# Access Compliance Report

## Public Rights-of-Way

### (Pedestrian Signals)

Intersection ID: N/A	Main Street:	Cross Street: N/A	Location: N/A
ADA ID: F02FBB227760	Signal Type: One Push Button-APS	Overall Compliance: No	Severity Score: BTN 1: N/A BTN 2: N/A No BTN: N/A
Codes/Mitigation Info/Possible Solution		Field Measurements/Component Compliance

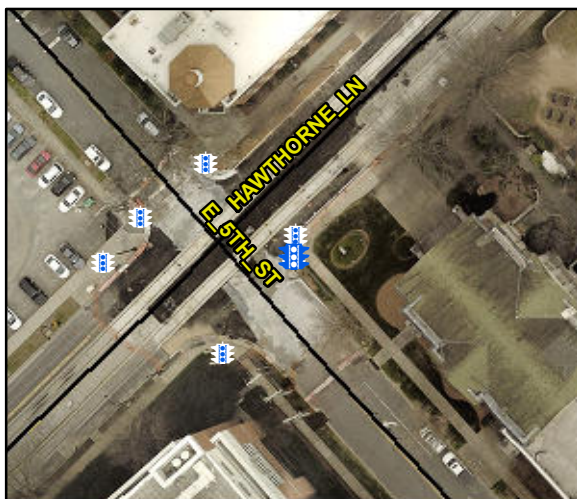
Possible Solutions: Replace Signal Push Button With APS Button on New Post. Remove & Relocate Sign.

PROW/ADA: , R404.2, R404.3, R406.2
